# Service Sheets for the

# Norton

## Commando

## SERVICE RELEASE

REASON FOR RELEASE: Incorrect assembly of front forks to frame.

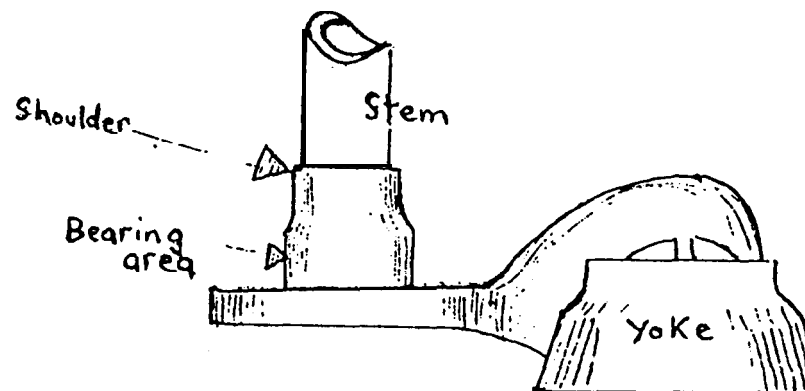
EXPLANATION: During assembly of the fork lower lug and stem to the steering head tube of the frame, it is possible for the shoulder of the stem to become lodged against the lower headrace. If this is not realised and the fork should turn on to full lock, the thick cross section of the yoke will lodge against the lock stop on the frame. As the stem is drawn home into the bearings by tightening of the large stem nut, the yoke cannot follow and will either be distorted beyond further use or fractured in the area where the stem joins the yoke.

ACTION: To prevent damage, ensure that the correct lower portion of the stem is central in relation to the lower bearing inner race before the stem nut is tightened.

NATURE OF RELEASE: Exhaust note.

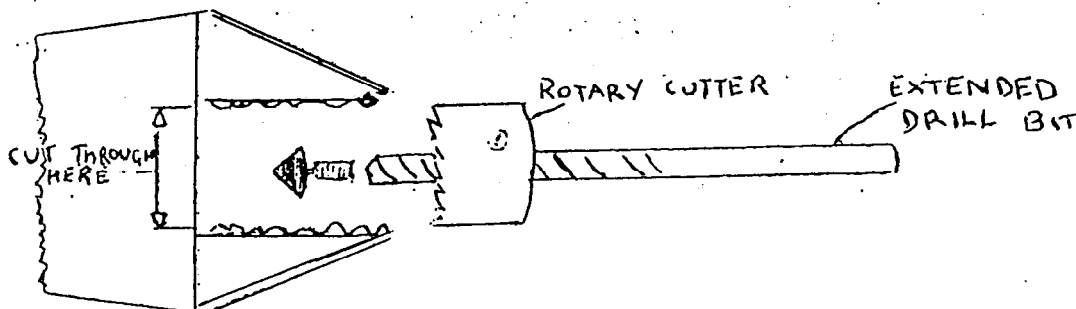
EXPLANATION: We are advised of sales resistance to machines fitted with the latest reverse cone silencers with perforated tubes in the end cones due to a whistling effect over subdued exhaust note.

ACTION: Using a 13/16" diameter sheet metal rotary cutter on an extended drill bit cut a hole through the blanking plate as shown below.

This modification makes it essential to change the main jets to 210 and to drop the needle in the clip to the top (No.1) groove. If carburation is not corrected after this silencer modification, severe damage will be caused. Observe that the resultant exhaust note still falls within legal requirements.

NATURE OF RELEASE: Warning light assmulator

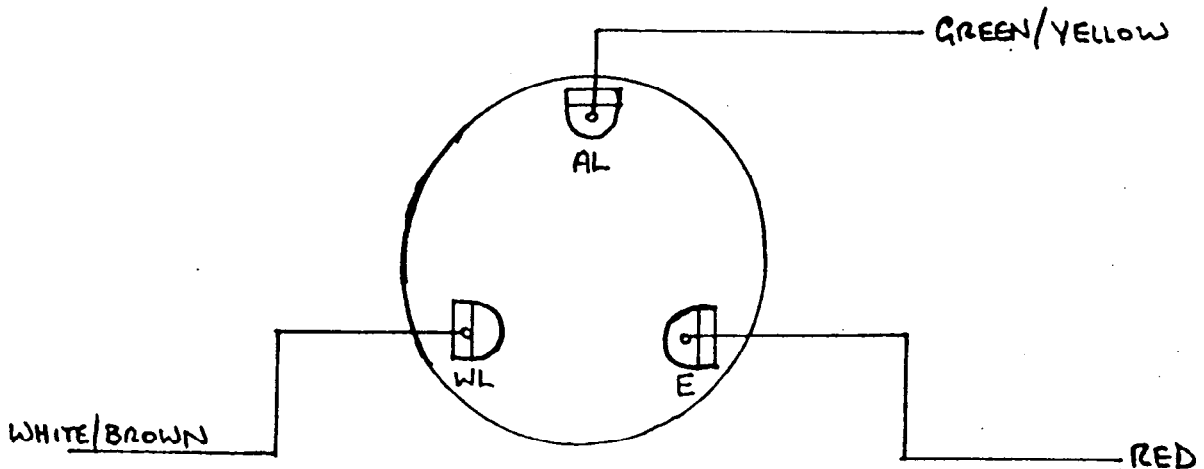
EXPLANATION: Instances have been reported of the charge warning light assmulator, being inoperative ie. the light has remained on when charging has been taking place. Investigation suggests that affected machines have had the leads to the assmulator connected incorrectly.

ACTION: Remove the fuel tank to gain access to the voltage assmulator connections. Ensure that the leads are connected as shown below.

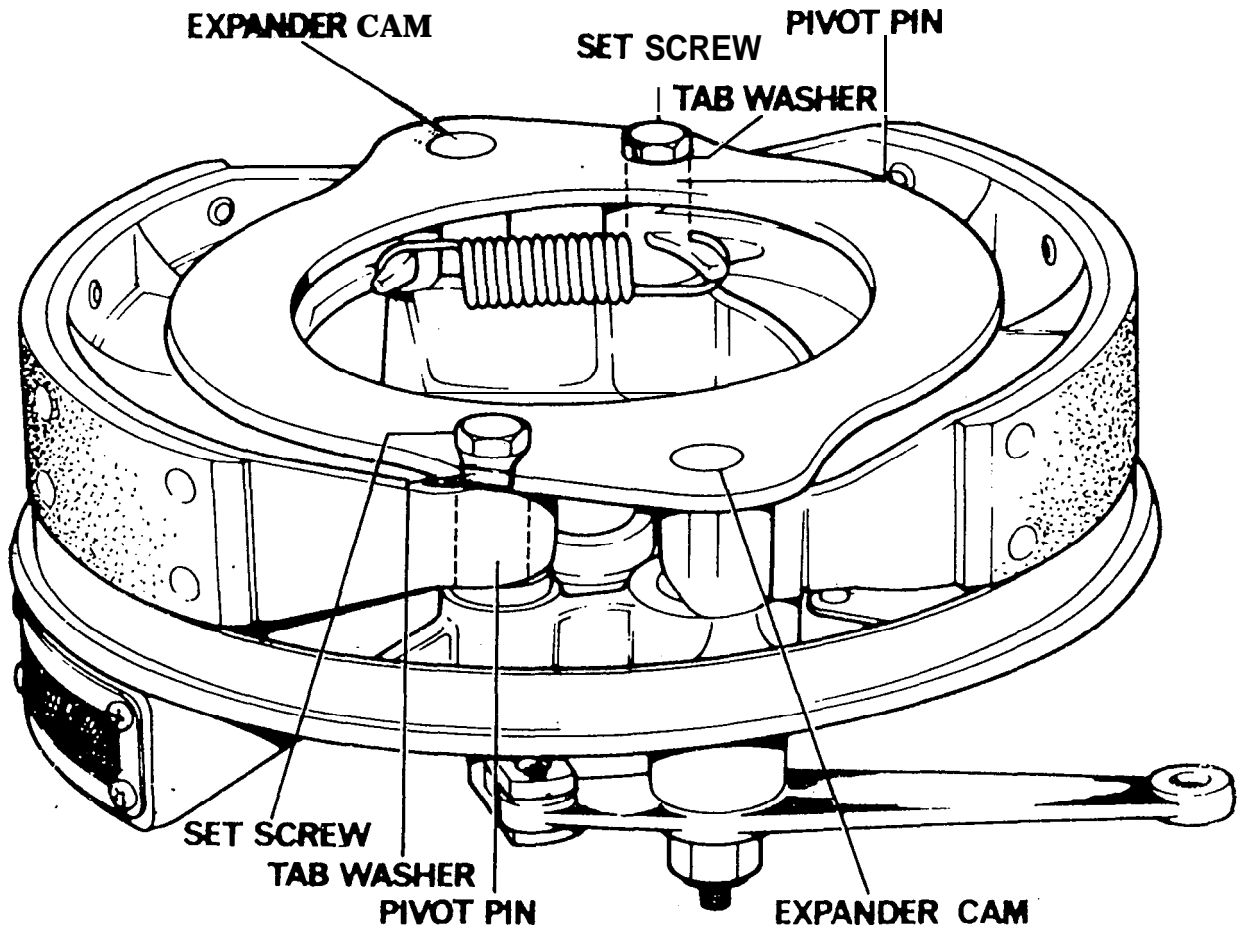
To stiffen up the two leading shoe front brake assembly, thereby providing an appreciable improvement in braking figures for high performance purposes, a support plate is introduced. The support plate ties in a precise relationship between both brake cams and pivot pins. The support plate is shown in the illustration, in situ. The parts required to convert an existing brake are available in kit, Part No. 063410, comprising:-

063275	Brake support plate	1
063274	Pivot/Torque stop pin	1
063273	Pivot pin	1
063272	Expander cam	2
26484	Set screw, support plate	2
060395	Tab washer	2

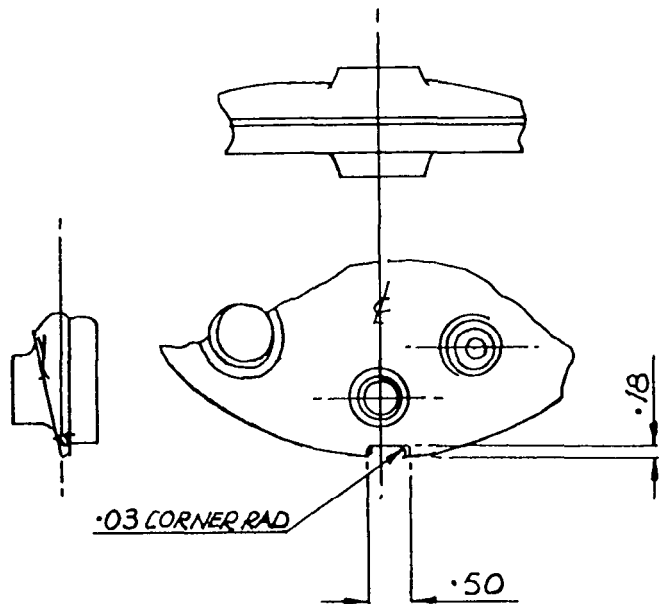
<u>Old Part No.</u>	<u>New Part No.</u>	<u>Extra Parts Req'd.</u>
<b>063087</b>	<b>063389</b>	
<b>062001</b>	<b>063389</b>	<b>063105</b>

When ordering a replacement stand for **063087** request part number **063389**. When ordering a replacement for **062001** request part number 063389 and spacer 063105 (for the pivot bolt).

FIG. 2. CYLINDER HEAD MODIFICATION

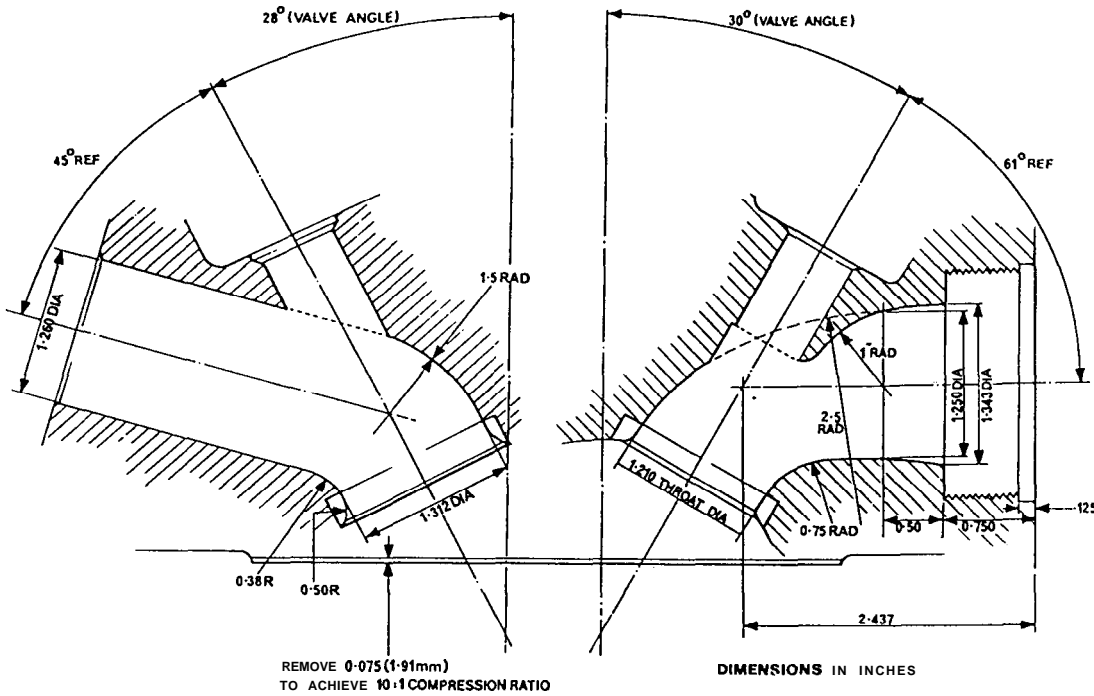
The diagram (Fig. 2) details the modifications that are recommended to increase the compression ratio to 10:1, and to convert both inlet and exhaust ports to the recommended shape to provide optimum power with flexibility.

**FIG.3 PUSH ROD MODIFICATION**

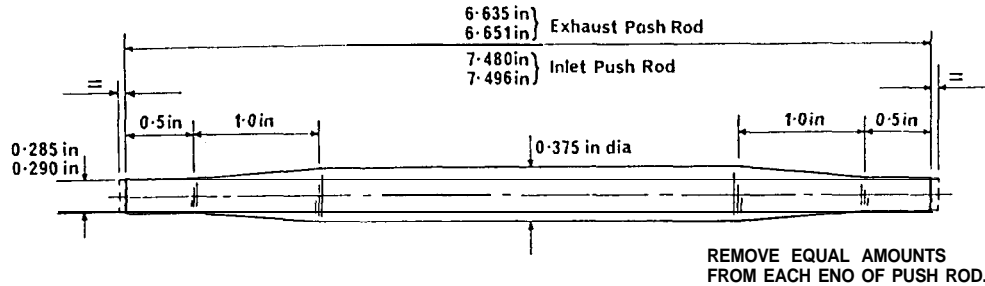
In order to maintain correct rocker geometry following removal of material from the cylinder head gasket face it is recommended that both end caps are removed from each of the four push rods, and 0.037 in (0.95mm) of metal removed from each end of the push rod prior to replacement of the end caps. Do not remove all the metal from one end only of the push rod as this may result in the end caps not re-seating properly, and only partially resting onto the taper run-out of the push-rod itself (see Fig. 4.).

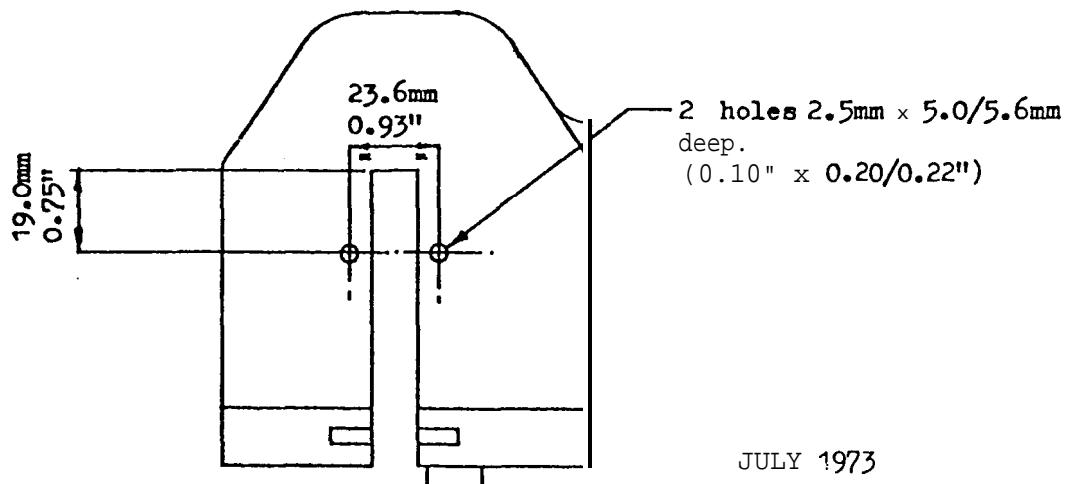
EXPLANATION: The existing front brake caliper 061927 (serviced as an assembly under part number 061926) has been modified by the addition of two 2.55mm diameter holes on the rear face, to allow the incorporation of a fully floating/self-aligning disc scraper part number 065143.

The scraper is designed to prevent dust and abrasive particles entering the caliper yoke and initiating abrasive wear of the disc and friction lining pads.

ACTION: The new part numbers involved are as under:-

065173 Caliper assembly incorporating disc scraper
